Quartz Valley Indian Reservation  
13601 Quartz Valley Road Fort Jones, CA 96032  
ph: 530-468-5907 fax: 530-468-5908

November 2, 2005

The Quartz Valley Indian Community of Quartz Valley Indian Reservation (QVIR), with the assistance of our consultants Kier Associates, have reviewed the public draft version of the North Coast Regional Water Quality Control Board's (RWB) Staff Report for the *Action Plan for the Scott River Watershed Sediment and Temperature Total Maximum Daily Loads* (Scott TMDL). As stated in previous comments, the Tribe hopes that the Scott TMDL will result in measurable and timely improvements in the water quality of the Scott River watershed. Please realize that QVIR is the only federally recognized, sovereign tribal government in the Scott Valley. The consideration that the Board gives to our comments should be representative of this fact.

## Summary of Comments

Figure 1. Suspected and confirmed range of coho salmon in the Scott River watershed. From CDFG (2004).

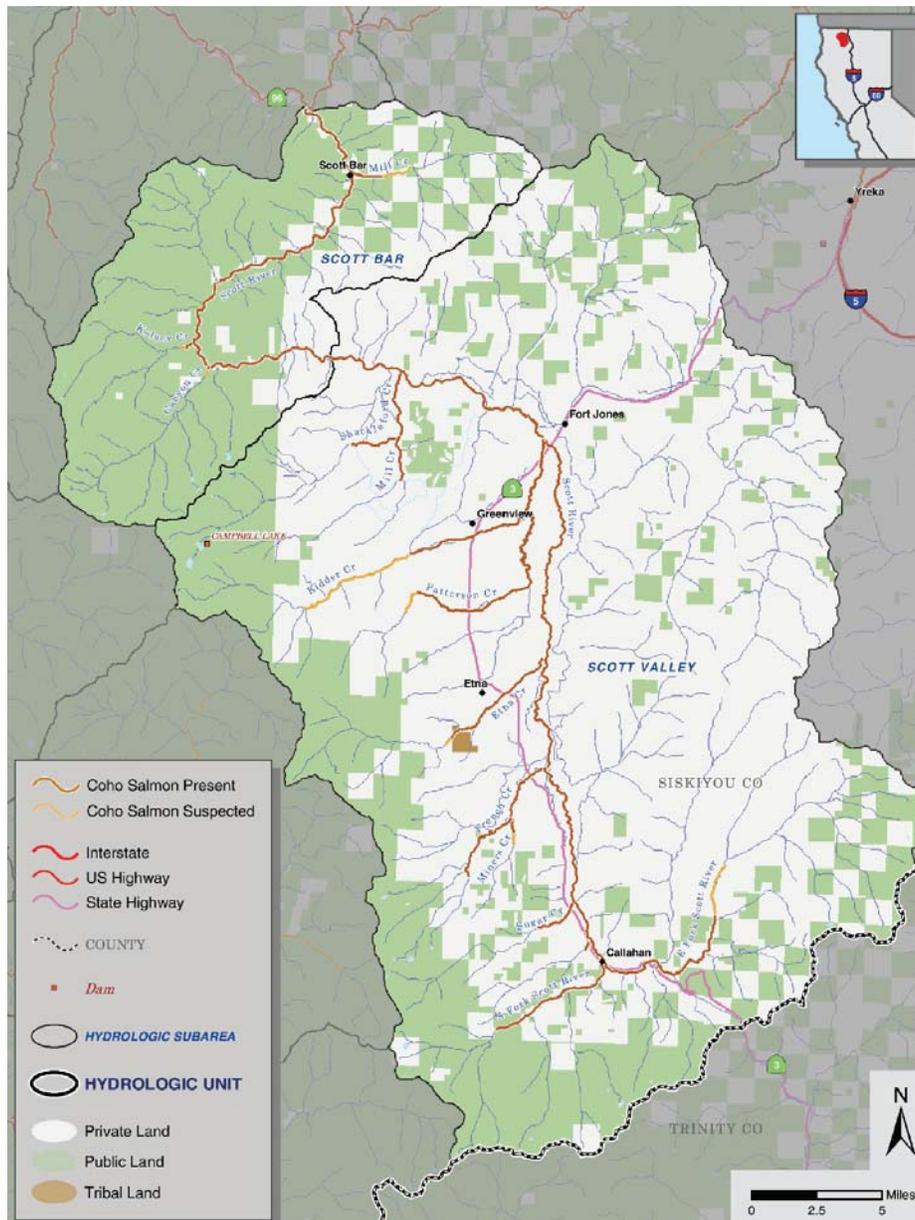
The final Scott TMDL needs to explicitly recognize what is known about coho salmon in the Scott River basin as recommended in early comments by QVIC (2004, 2005b). We suggest that the following language be added to the end of the second paragraph on page 2-5 (after “... no population estimates were made from this information): “In recent years, many surveys have been conducted to identify locations where coho salmon spawn (Quigley, 2005, Maurer, 2002; Maurer, 2003; SRCD, 2004). These data provide clear indication of a difference in strength between year-classes (two are weak and one is strong), and that all

three brood years are showing positive trends (SRCD, 2005). CDFG (2004) and others have produced detailed maps of coho salmon distribution within the Scott River watershed (Figure 1).

Figure 2. Data from CDFG spawner surveys show that fall chinook salmon spawned mostly in the lowest five reaches of the Scott River in 2001 and 2002, where eggs may be vulnerable due to high bed load of decomposed granitic sands.

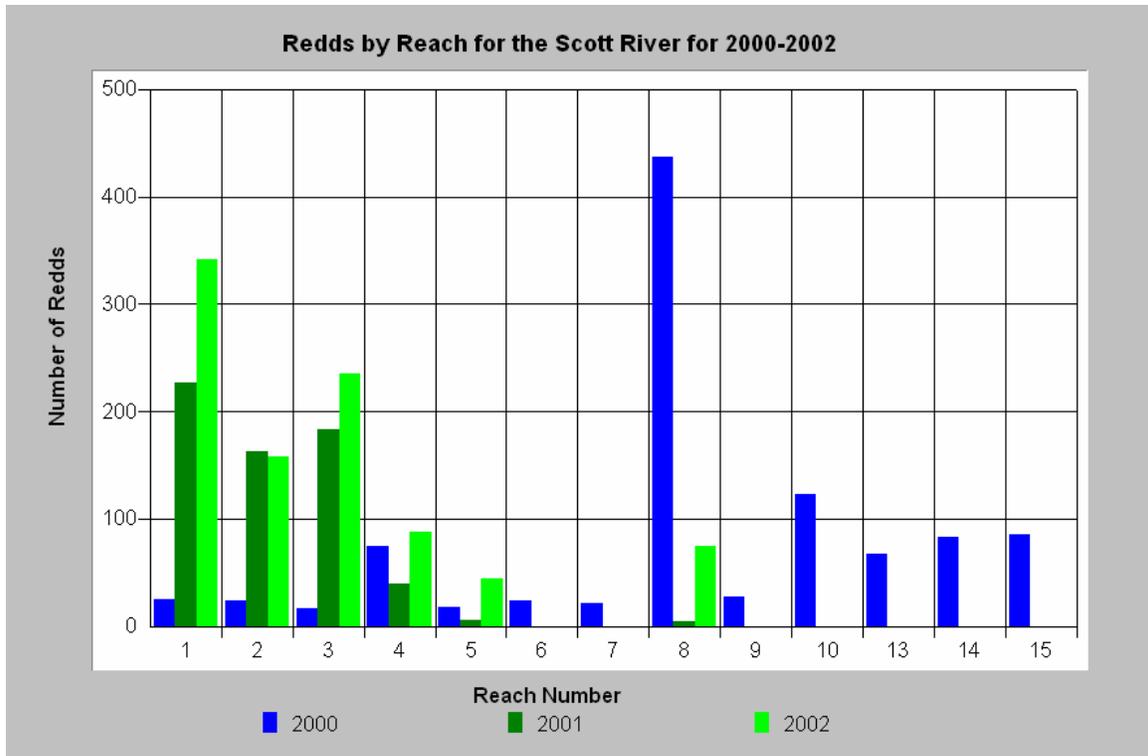
While the Scott River TMDL posted a chart of fall chinook salmon trends, it did not discuss the fact that the 2004 adult return was the lowest of all time. The South Fork Trinity TMDL (U.S. EPA, 1998c) has goals for recovery of fall and spring chinook populations and the final Scott TMDL should advance similar biological targets. Kier Associates (1999) point out that egg survival of fall chinook spawning in the Scott River canyon may be low due to the potential for intrusion of sand into redds. The final Scott TMDL needs to recognize the basin's pattern of use by fall chinook and specifically address the abatement of sediment problems in the canyon where California Department of Fish and Game data show they spawn (Figure 2).

Figure 3. This figure shows the road density classification for the Interior Columbia River basin that is recognized by the USFS (1996) in relationship to maintaining aquatic biodiversity.

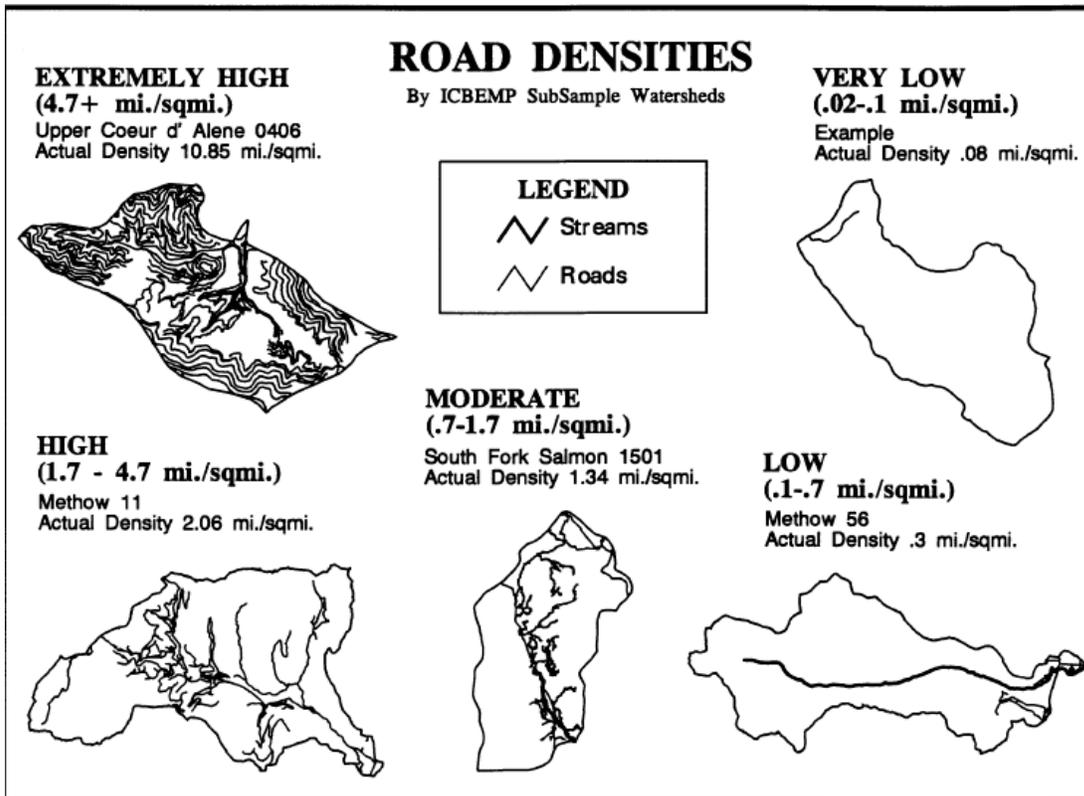
The issues raised by Kier Associates (2004, 2005a, 2005b) regarding road density have not addressed in the draft Scott TMDL. While recognizing that problems are sometimes associated with roads, there is no target or threshold set to remedy impairment. Although the Scott TMDL mentions road density limits of 2.5 mi. /sq. mi. set by Armentrout et al. (1999) for those Lassen National Forest streams which harbor anadromous salmonids, it fails to set a similar standard: "The Scott River TMDL Action Plan does not propose road density as a specific desired condition for the Scott River watershed, although a decreasing trend in road densities would be beneficial." This is only one of many areas where there is no enforceable, follow-up action to assure the abatement of water quality problems. A target for road densities of less than 2.5 mi./sq. mi should be included in Table 2.4.

Figure 4. This map is of the upper Patterson Creek drainage and shows mapped roads in red, but USGS orthophotos also displayed show many more roads than are mapped.

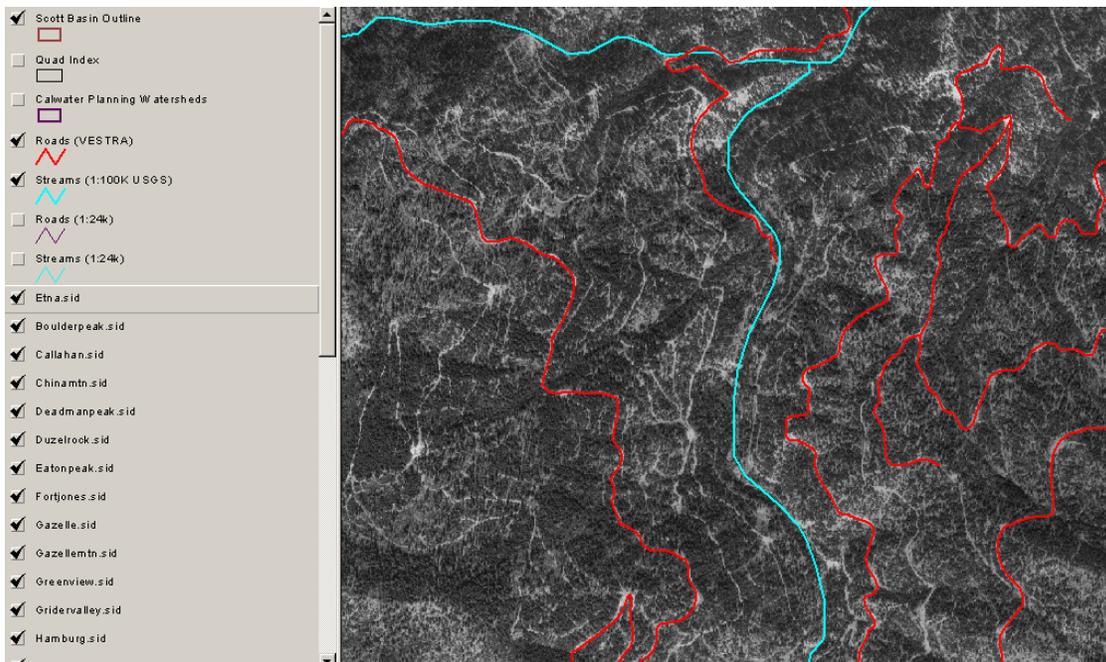
The VESTRA-developed GIS layer of roads used by the RWB for its TMDL under-represents roads and skid trails in some areas of the Scott watershed (Figure 4). Only major haul roads are included, which means that many temporary roads and skid roads that can increase erosion remain unaccounted. This should be noted under margins of safety in 3.5.4.

Figure 5. This map is taken from an ArcView project by Derksen (2005) and shows that the risk of shallow debris torrents in the lower Scott River is high and that the large majority of landslides mapped by Klamath National Forest scientists occurred on areas shown here as high risk.

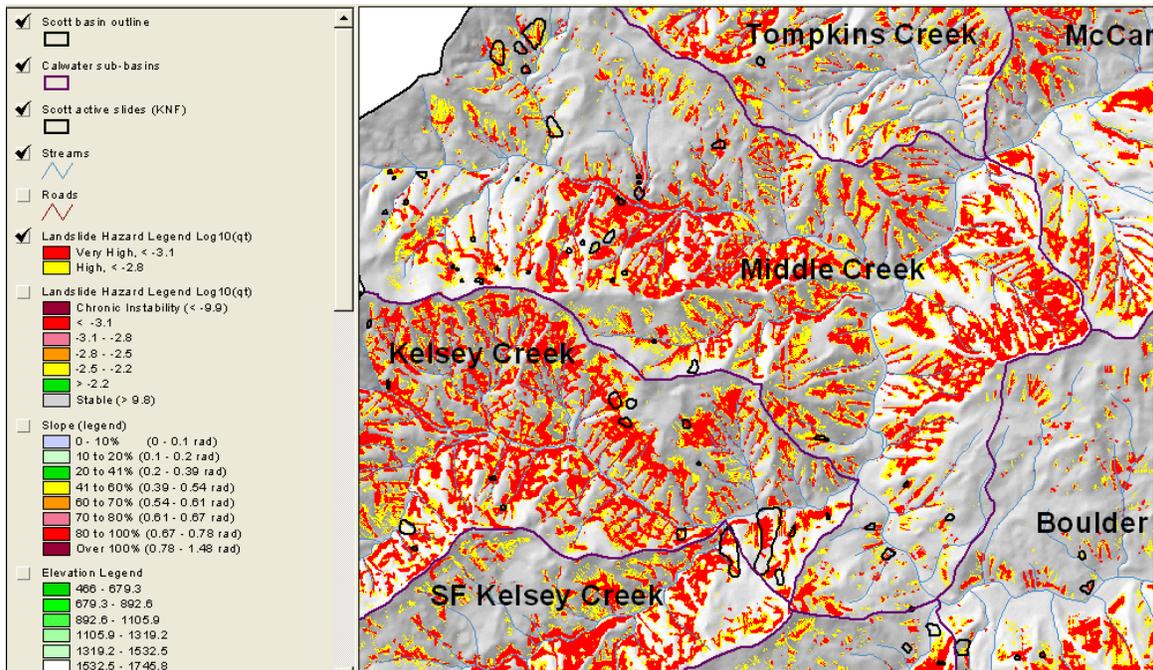
We recommend that the RWB and other use SHALSTAB as a preliminary screen, not necessarily as the ultimate decision tool, to identify unstable areas requiring protection in the Scott TMDL. If actions are proposed in the identified areas, then an on-the-ground survey by a geologist could provide field-based information to supplement the SHALSTAB model.

SHALSTAB maps should be included in Section 2.4.3.6 of the TMDL, and should also be made available electronically in a GIS format. The SHALSTAB maps should also be used in GIS analyses to quantify the percentage of the predicted unstable areas that have been disturbed in each Calwater Planning Watershed.

Figure 6. This chart shows change scene detection for 40 Calwater Planning Watersheds in the Scott River basin based on USFS and CDF interpretation of Landsat scenes from 1994 and 1998.

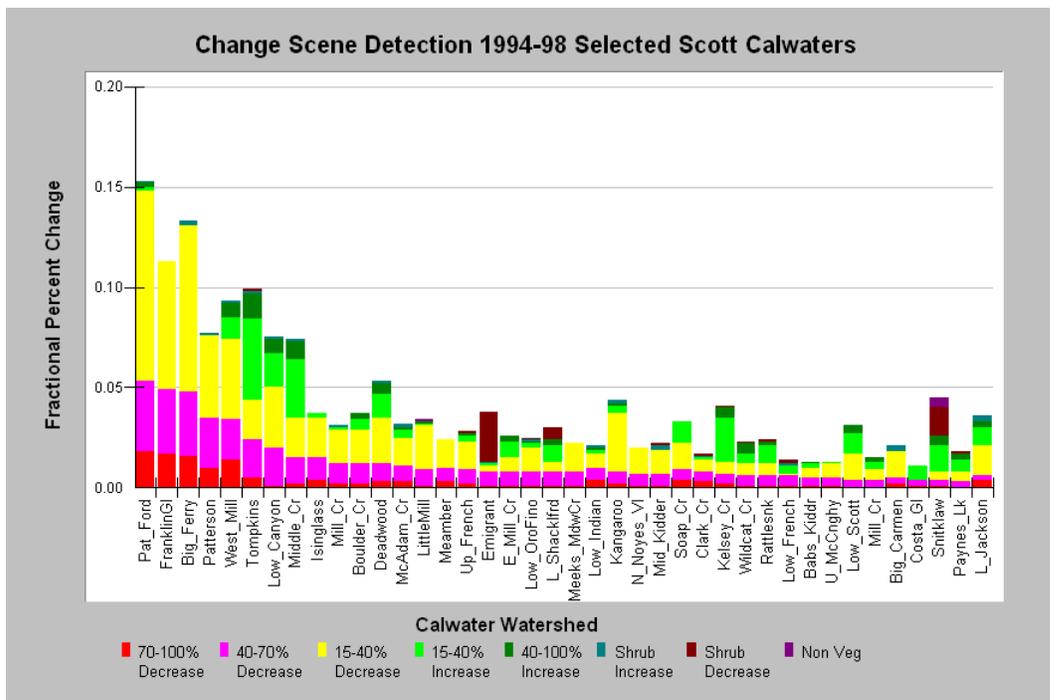
The RWB staff should be using remote sensing data for reconnaissance and analysis, such as change scene detection, to understand the patterns of landscape disturbance and forest growth and to build that knowledge into the TMDL. Change scene detection involves the use of a series of Landsat scenes from different years in order to compare patterns in landscape change over a given period (Levien et al., 2002). The necessary data are available from the California Department of Forestry (CDF) and U.S. Forest Service Spatial Analysis Lab in Sacramento for the period 1994-1998.

Figure 6 shows a summary of change scene data from 40 of the 68 Scott River Calwater Planning Watersheds sorted by the highest level of disturbance. Areas with the highest rates of recent disturbance have the greatest risk of CWE and should be studied as a priority and called out as a concern. The northeastern and northwestern parts of the Scott Valley (the West Canyon and East Canyon sub-basins) watersheds had the highest change in vegetation owing to the high rates of timber harvest on both private and USFS lands. Patterns of disturbance include sensitive headwaters areas, inner gorge locations, and riparian zones (Figures 7 and 8).

Figure 8. Change scene detection from 1994 and 1998 Landsat images for West Canyon sub-basin areas shows forest canopy reduction from logging (orange and red) and forest regrowth (green) where trees are growing back in areas formerly harvested or burned.

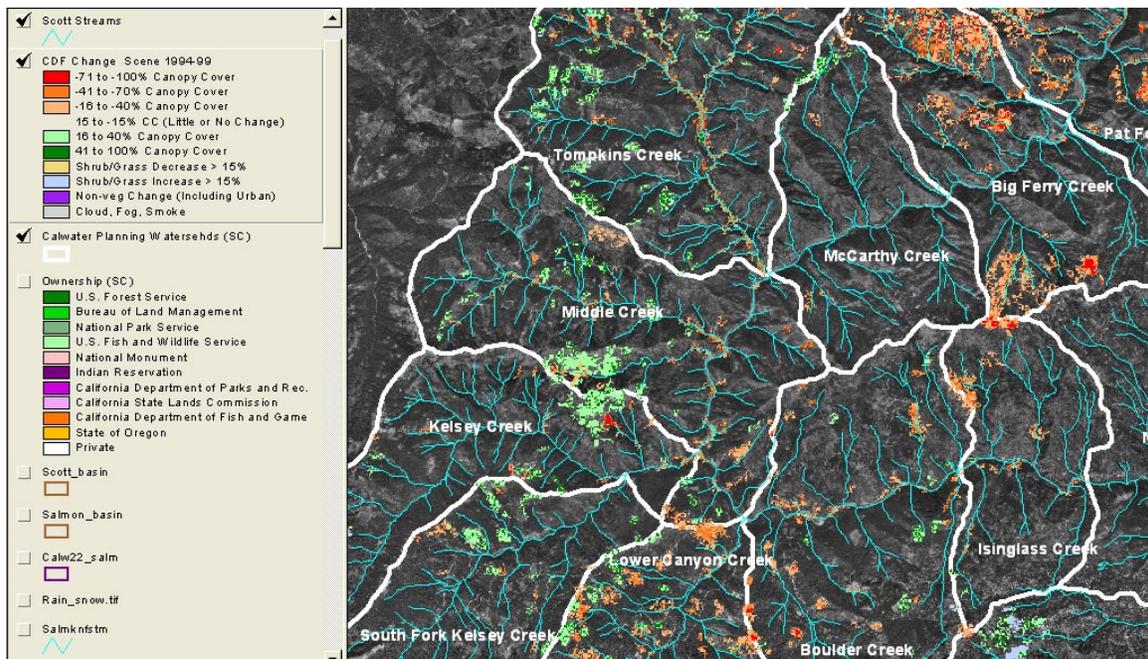
The West Canyon (northwestern area of Scott watershed) is largely owned and managed by the U.S. Forest Service, but timber harvest activity is widespread (Figures 7 and 8). While canopy reduction shows areas recently harvested, it shows tracks of debris torrents and channel scour as linear patterns bordering Tompkins Gulch and lower Middle and Kelsey

Figure 8 shows change scene data for 1994-1998 in the East Headwater TMDL sub-basin with extensive timber harvest, but little forest re-growth. Figure 9 shows Klamath National Forest timber harvests by decade in the Kangaroo Creek and Big Carmen Calwater Planning Watersheds, followed by remote sensing vegetation data in the same area (Figure 10). Comparing the two maps shows that there was little or no re-growth after timber harvest in the 1980s with the polygons of previously logged areas showing up clearly as Non-Forest or Saplings. This indicates problems with forest regeneration. Such stunting would lead to increased and continuing risk of damaging flows due to rain-on-snow events.

Figure 9. This summary chart is based on data from de la Fuente and Elder (1998) regarding 1997 flood effects and shows few landslides occurred on undisturbed lands of the Klamath National Forest, and slide frequency was associated with human disturbance.

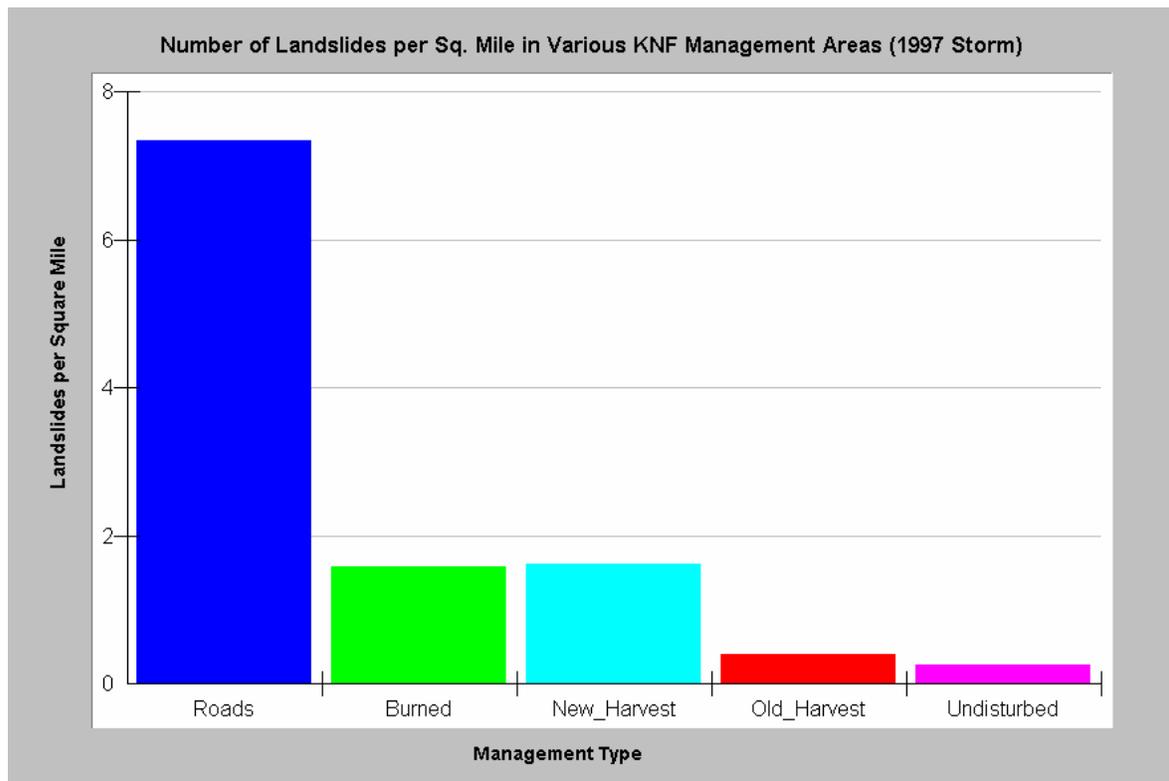
Although the TMDL did not identify impacts from landslides and sediment to the East Fork Scott River sub-basin, the East Fork experienced channel scour and flood damage as a result of the January 1997 storm event (Kier Associates, 1999). Timber harvest was high during the period of 1994-1998 on public and private land in some areas that are likely subject to rain-on-snow events in this sub-basin (Figure 8). Patterns of disturbance in transient snow zone and linkage to increased peak flow and channel scour of the East Fork need to be explored. Lack of tree growth in areas previously harvested may cause a window of extended risk for rain-on-snow events (Figure 9). Patterns of road failures from de la Fuente and Elder (1998) are similar to other areas in the transient snow zone. These patterns likely extended to private timber lands in the Westside TMDL sub-basin but lack of access to private lands prevented appropriate assessment by RWB staff.

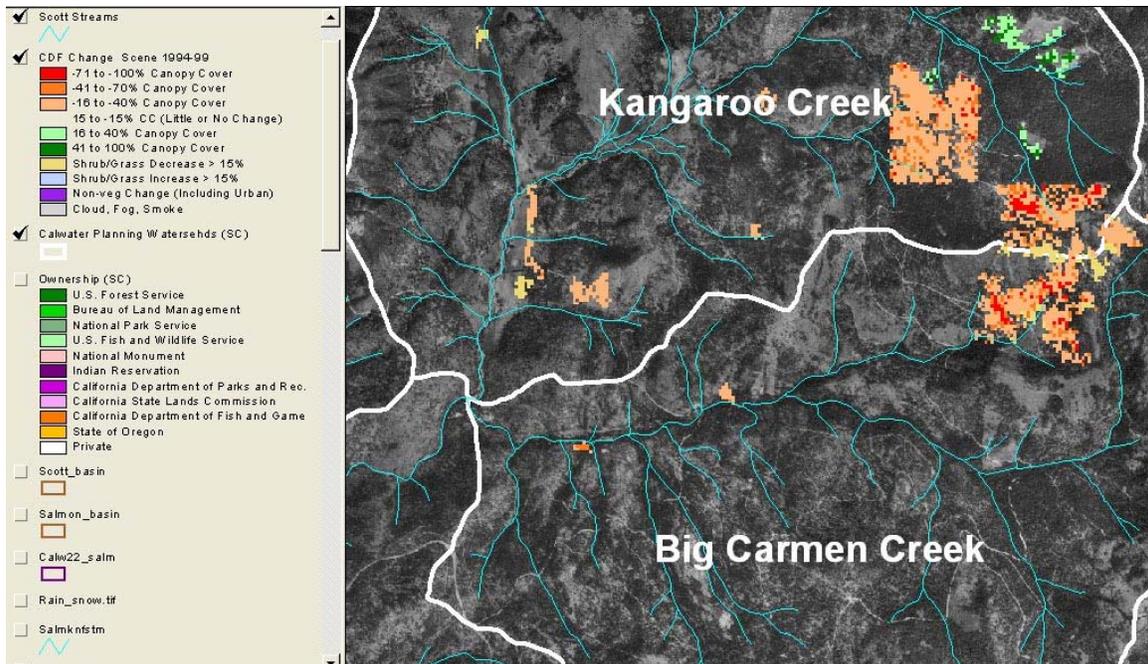
A map of the transient snow zone (Figure 11) needs to be added to the Scott TMDL as well as a discussion of increased peak flow, channel scour and resulting increased water temperature. The rain-on-snow zone information provided by Kier Associates is based on Armentrout et al. (1999) and recognizes 3,500 to 5,000 feet in elevation as the area of greatest risk. In order to truly remediate problems as required by law, the TMDL should call for reduced road densities and timber harvest, especially in the transient snow zone.

Figure 15. Summary chart showing fine sediment less than 6.4 mm at 11 mainstem Scott River locations and at four tributary locations.

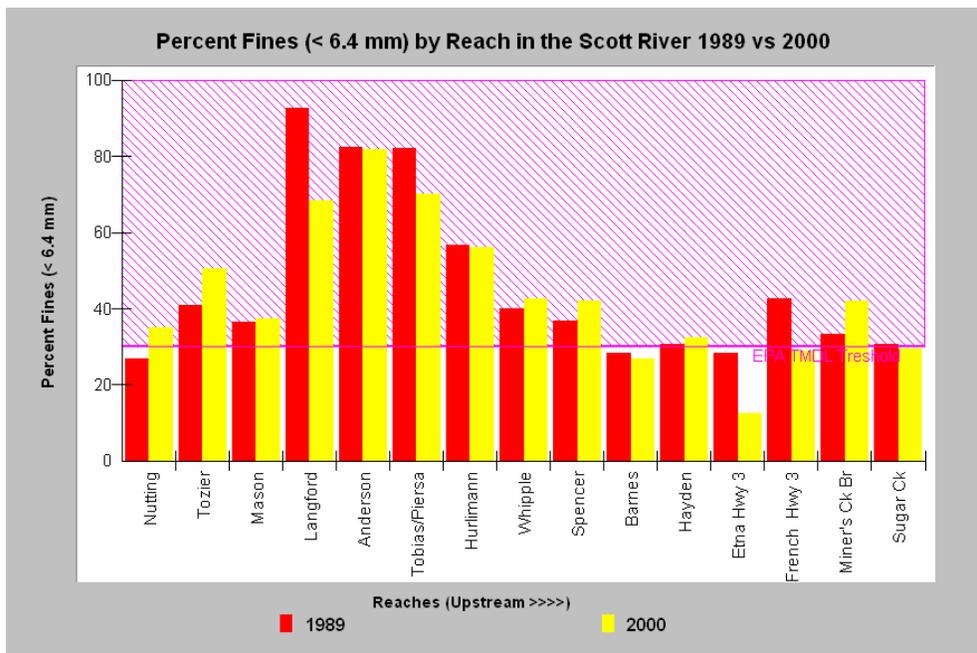
Discussions of sediment trends as measured by Sommarstrom et al. (1990) and Sommarstrom (2001) need to acknowledge that pollution from sand sized sediment is increasing at most locations, not decreasing (Figure 12). The extremely high fine sediment levels at mainstem Scott River locations indicate that there is still a substantial over-supply, although French Creek and Etna Creek sediment less than 6.4 mm decreased.
